ADDENDUM NO. 01 June 24, 2025

To Drawings and Specifications dated June 10, 2025.

PKG 3A – GPHS New Fieldhouse

Prepared by:	PBK
	11 Greenway Plaza, 22 nd Floor
	Houston, TX 77046-1104
	PBK Project No: 240539

Item No. 02 C101 -Site Plan

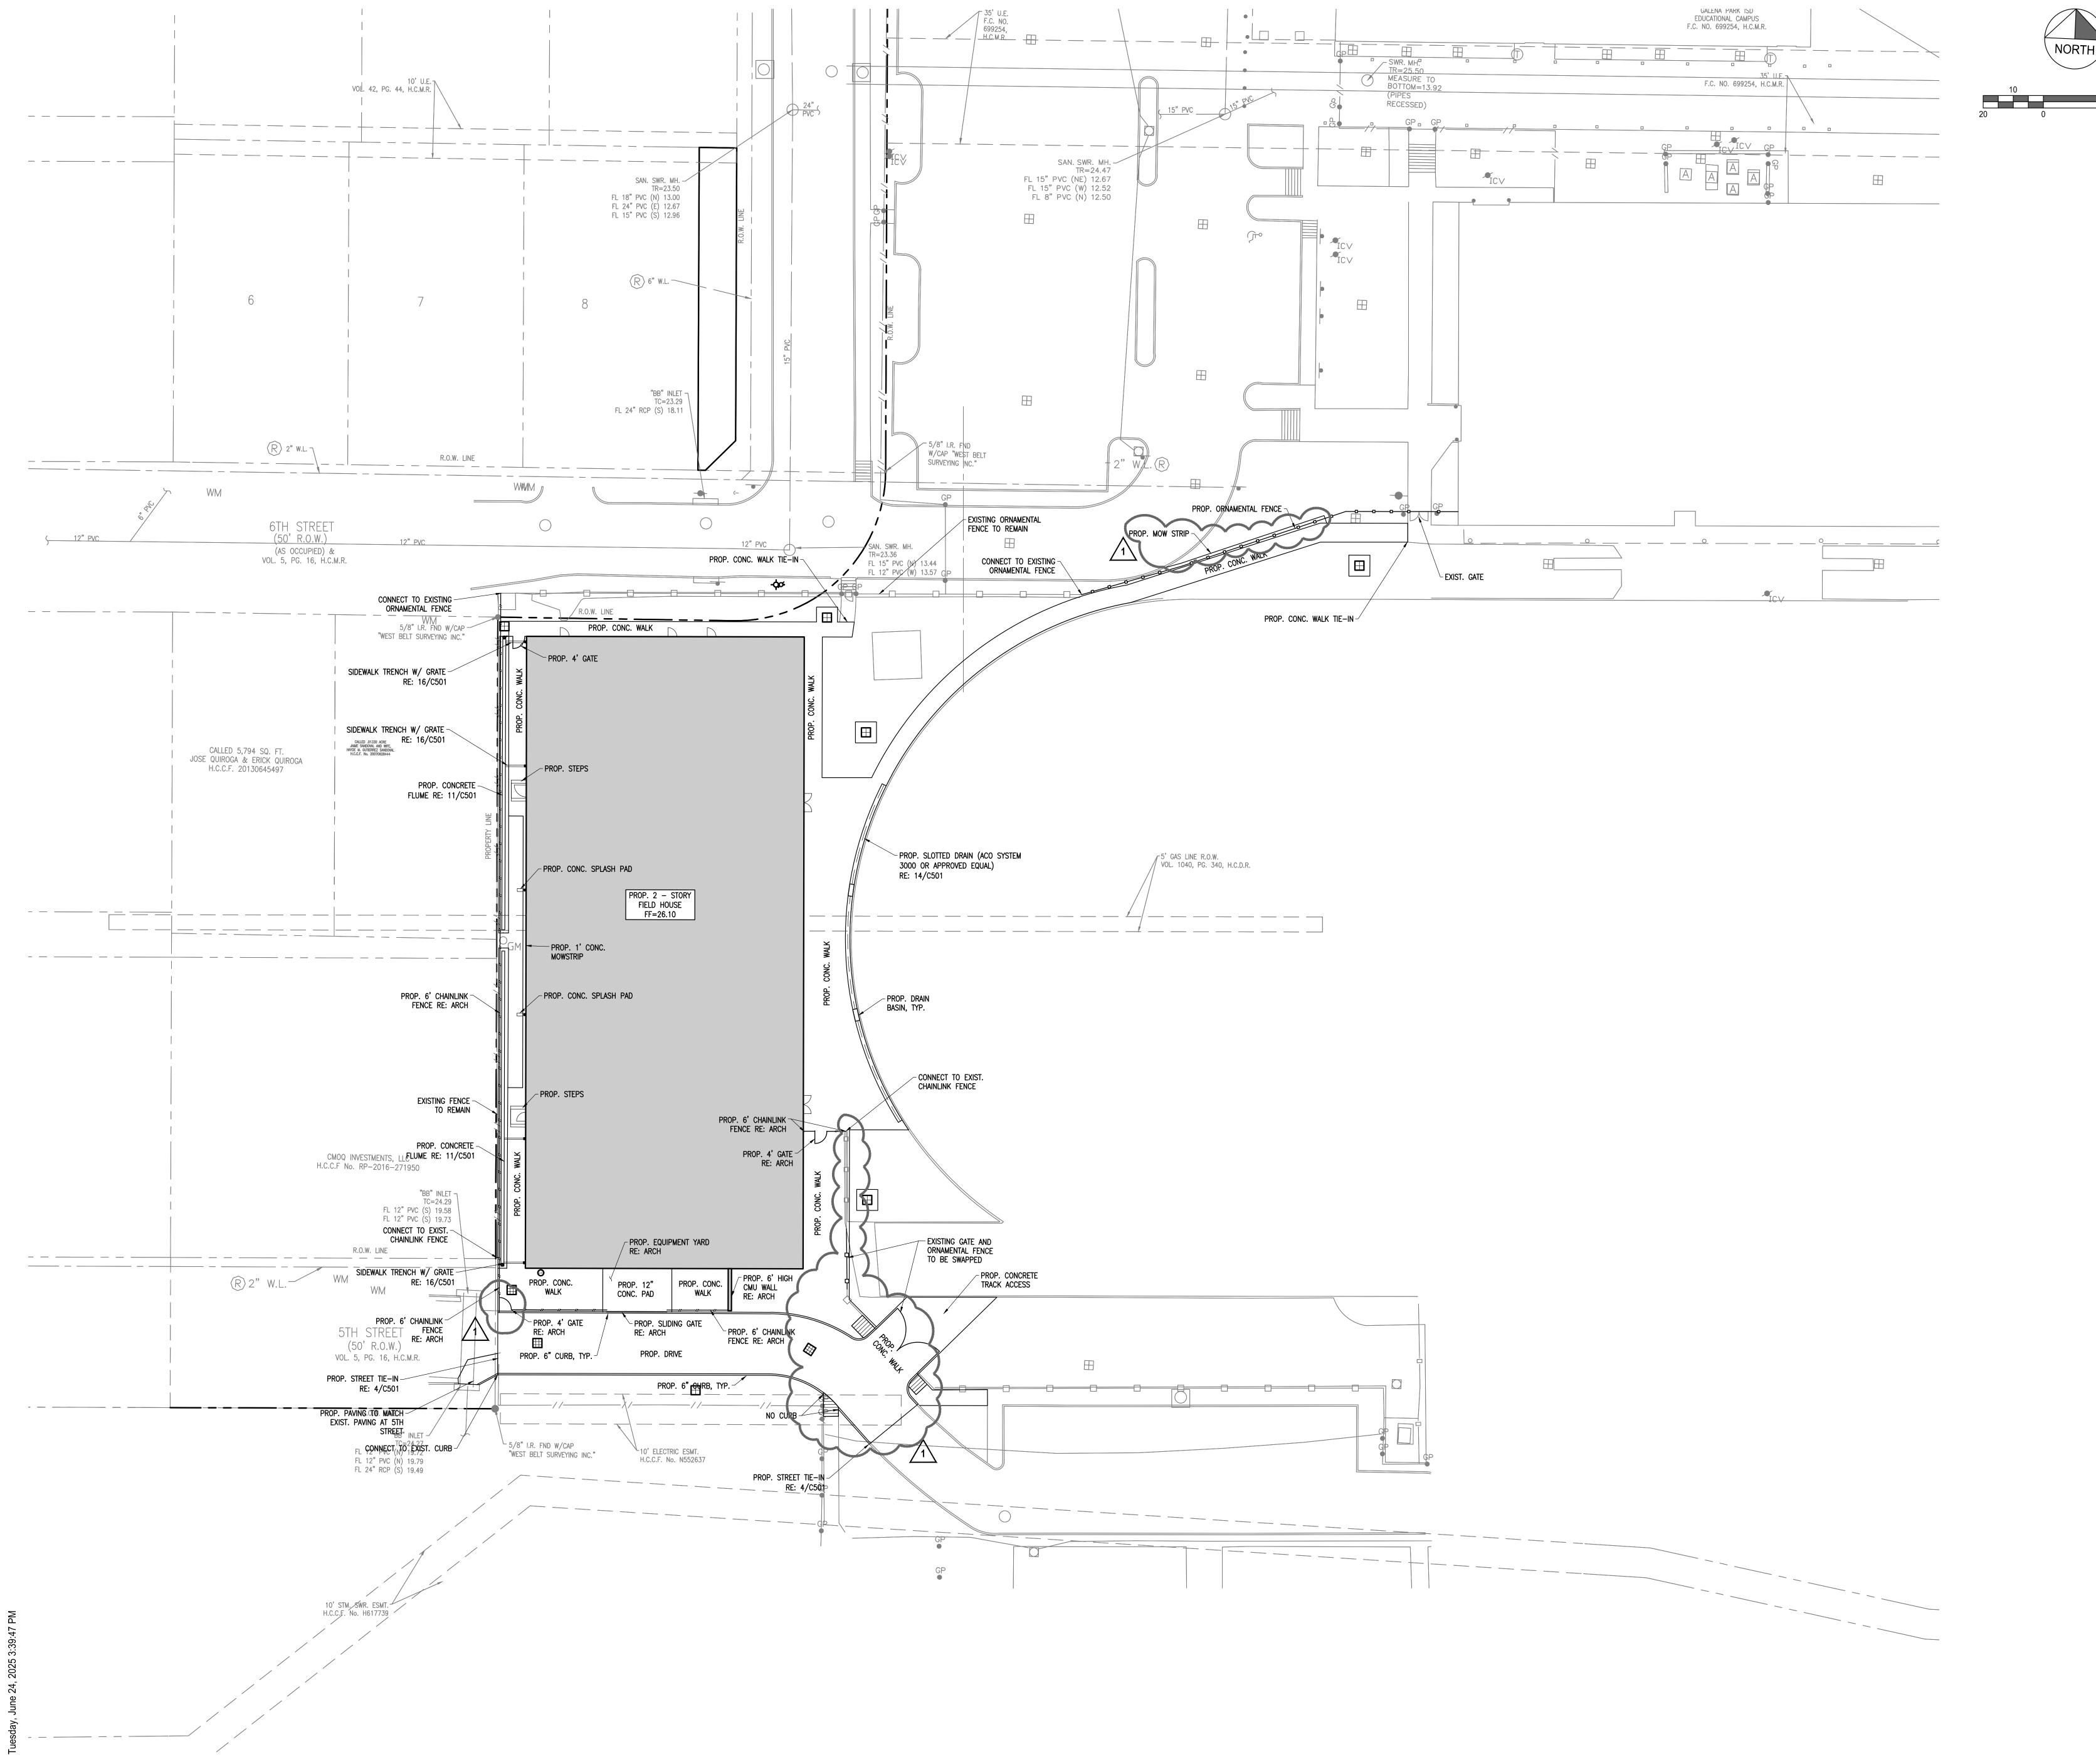
- A. The direction of the gate swing changed towards the equipment yard.
- B. Add conc. sidewalk width by 5'-3" on southeast corner of the building north of fire lane.
- C. Handicap Ramps added. Item No. 06: Add 56'-0"x 2'-0" mow strip.

Item No. 03 C201 -Drainage and Utility Plan

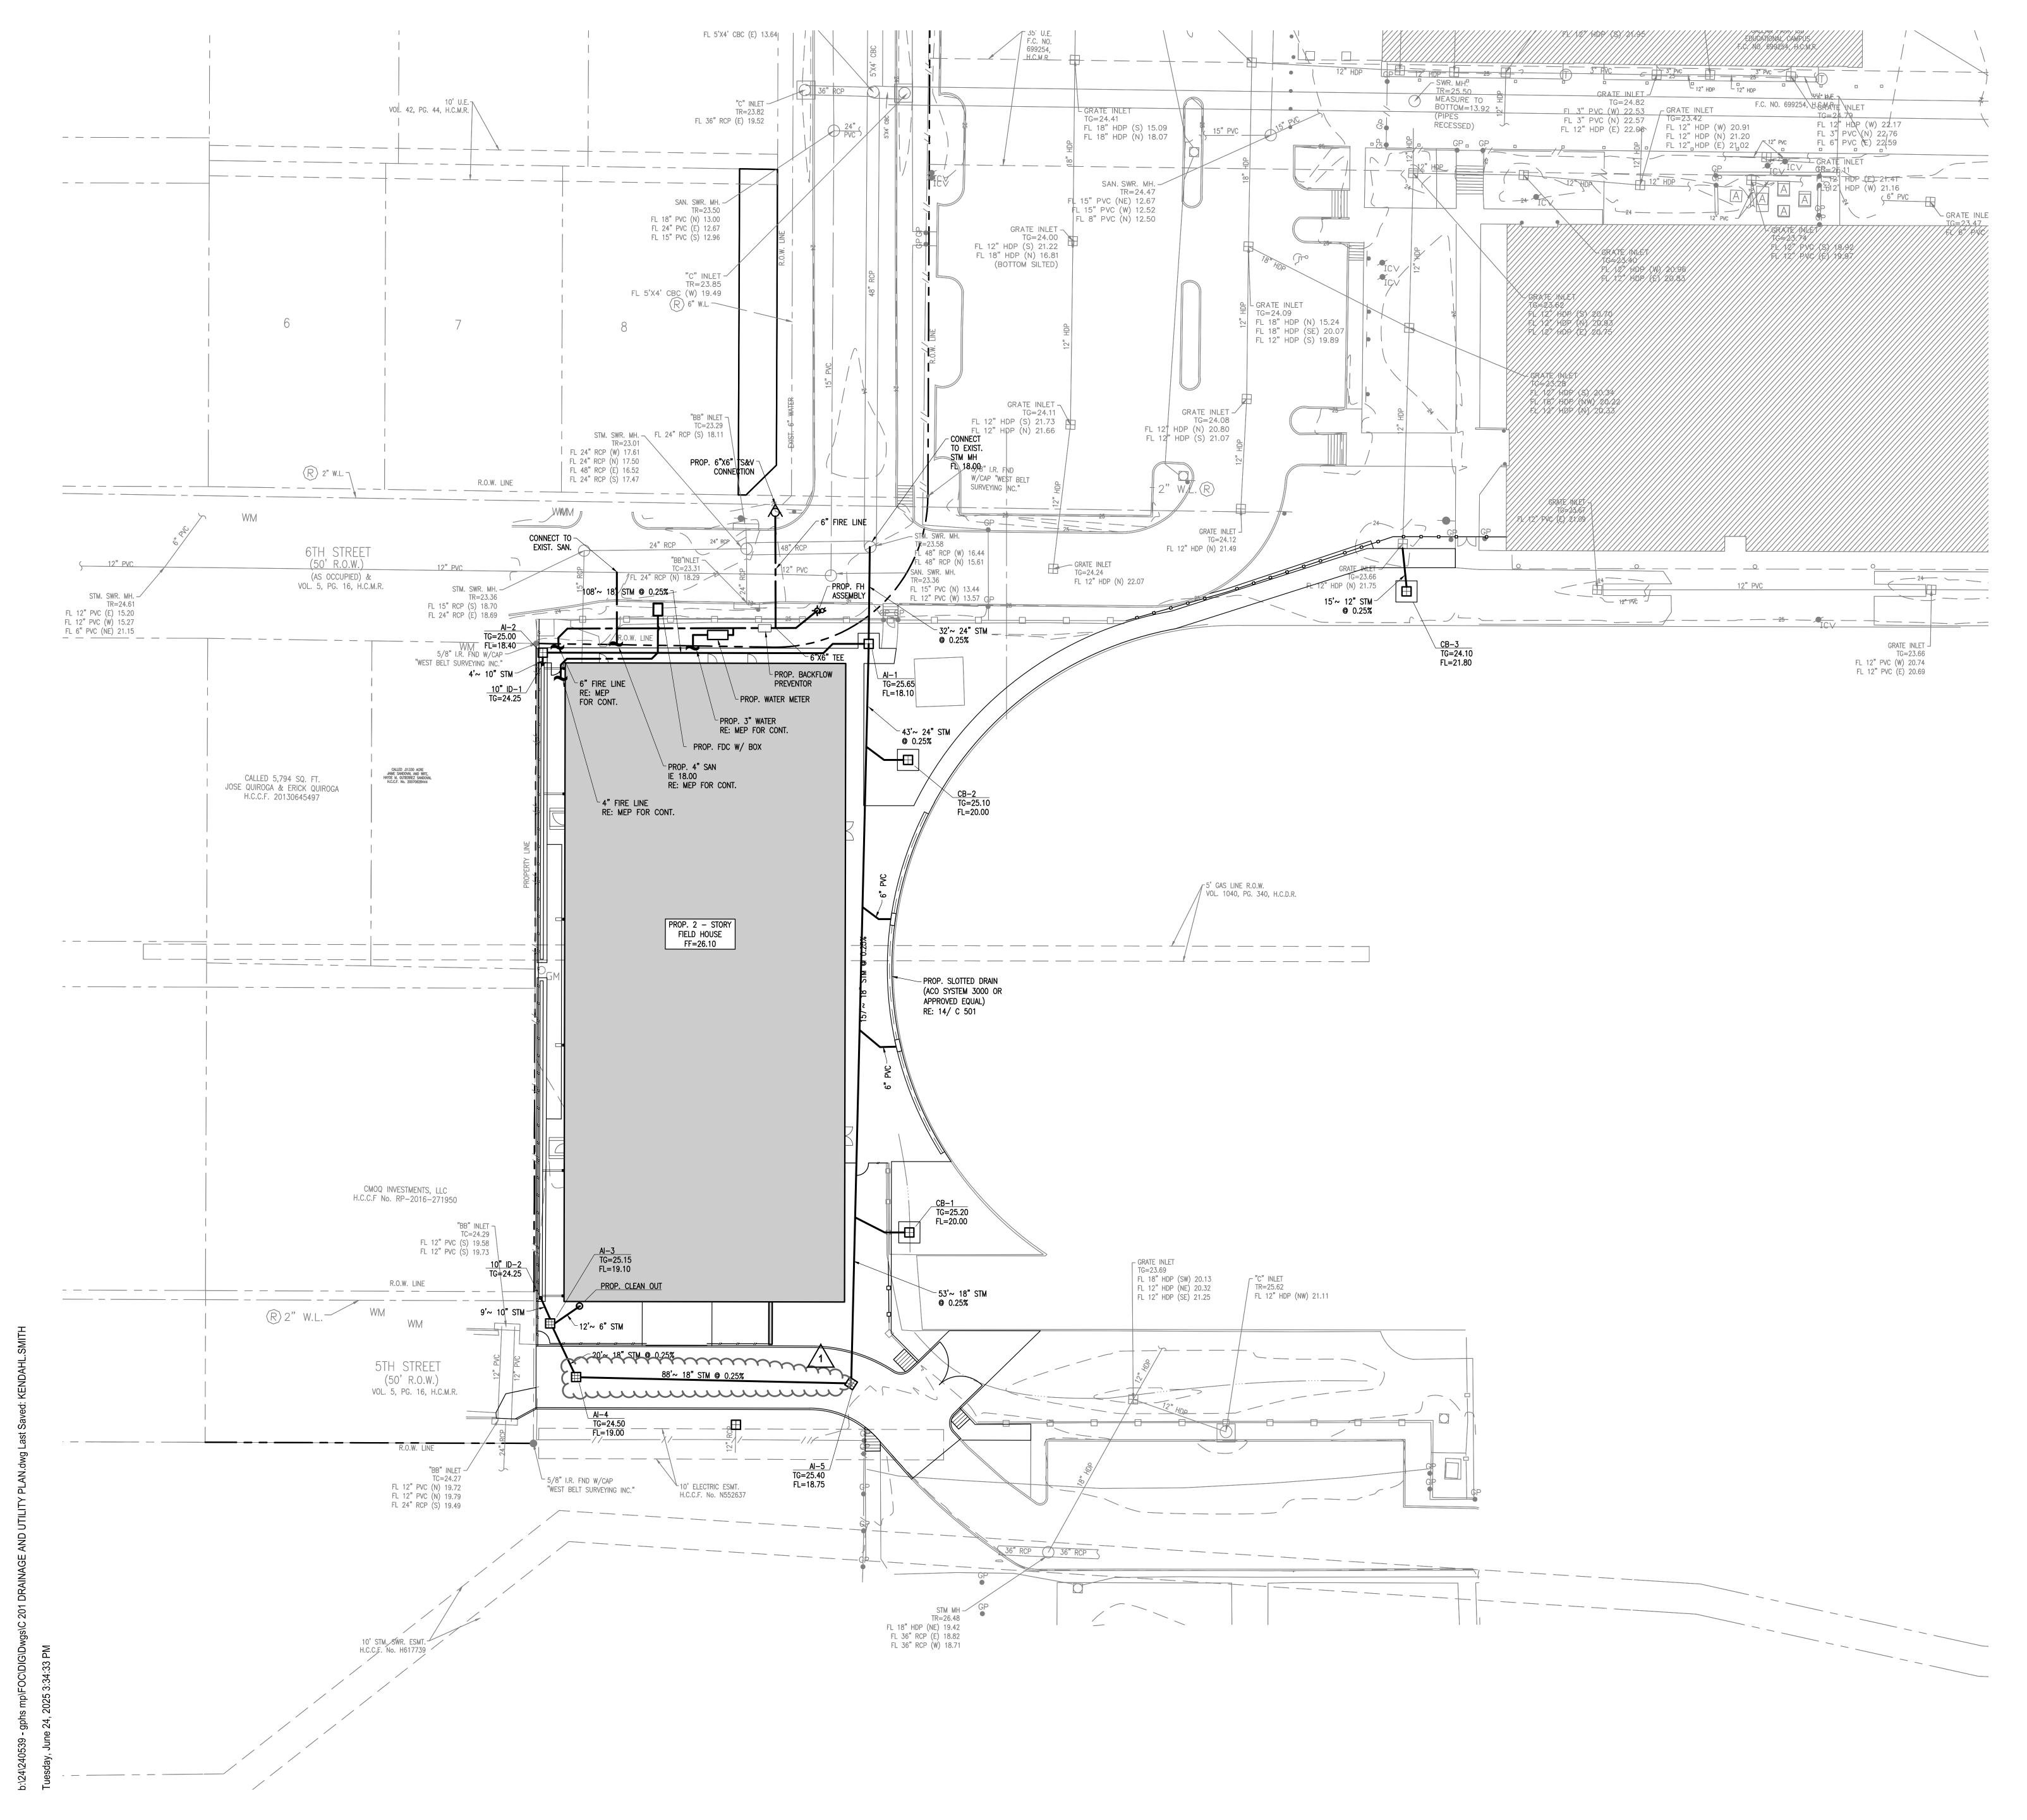
A. Change 18" Storm sewer pipe length to 88LF from 98LF.

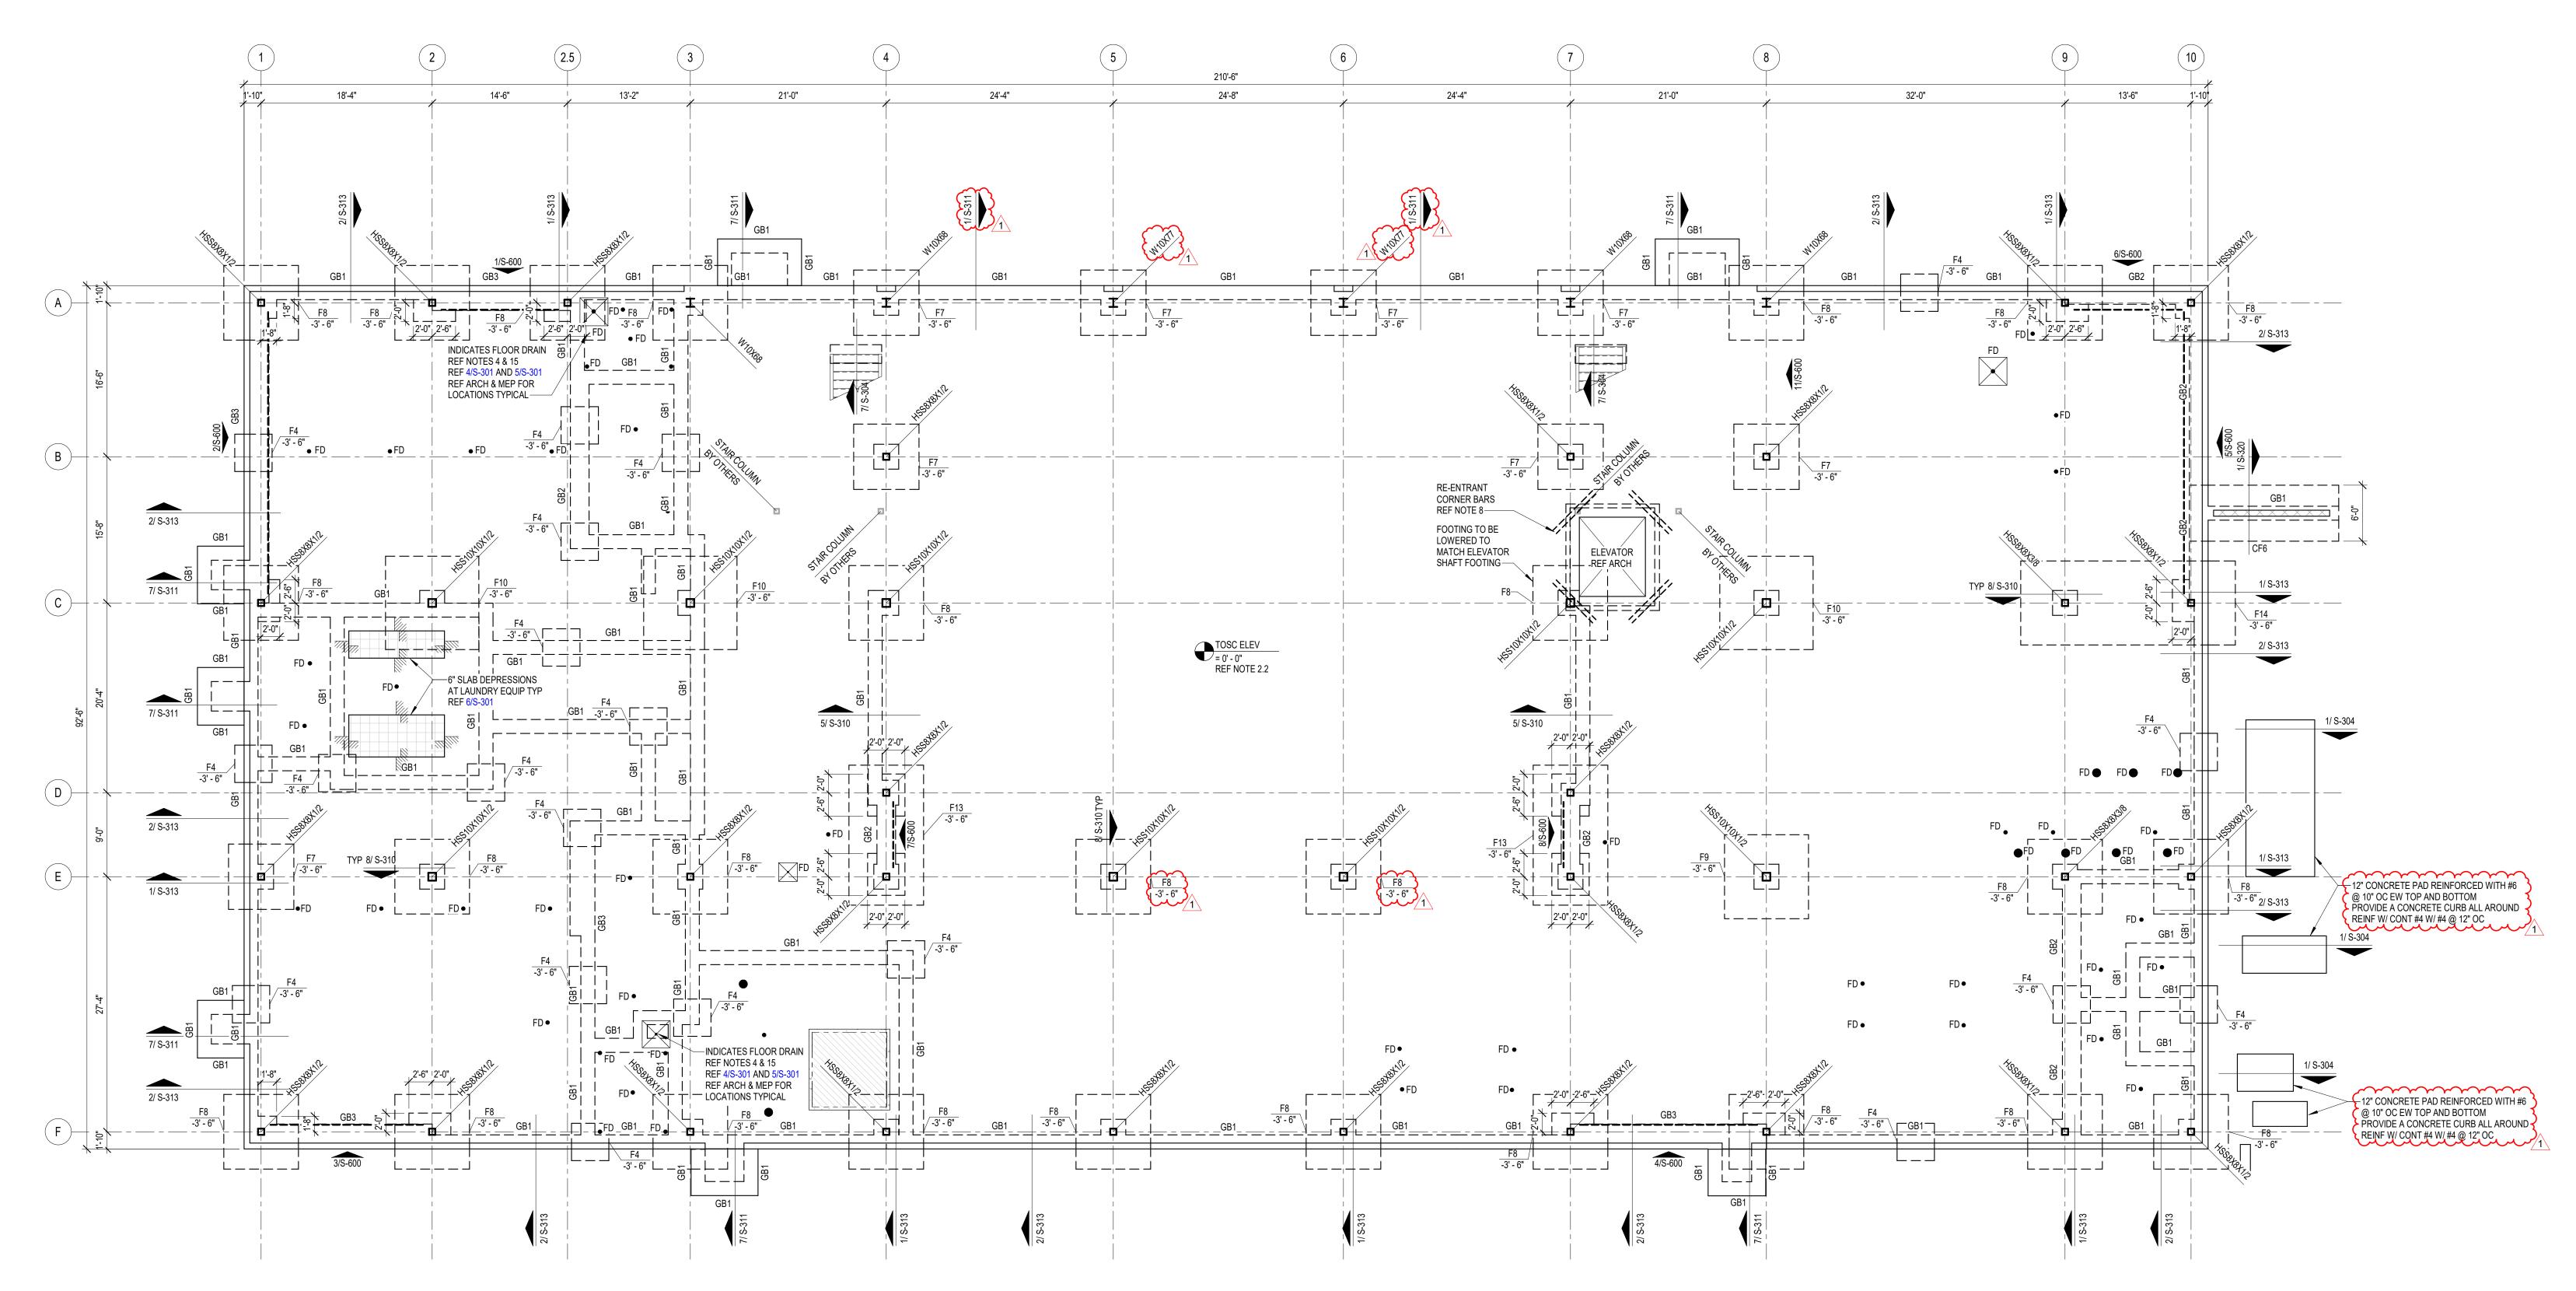
S-101 Foundation Plan
	Adjusted column sizes at A-6 and A-7.
	Adjusted footing sizes at E-5 and E-6.
	Changed section provided along grid A.
Item No. 02	S-102 Second Floor Framing Plan
Α.	· · · J · · · · · · · · · · · · · · · · · · ·
В.	· · · J · · · · · · · · · · · · · · · ·
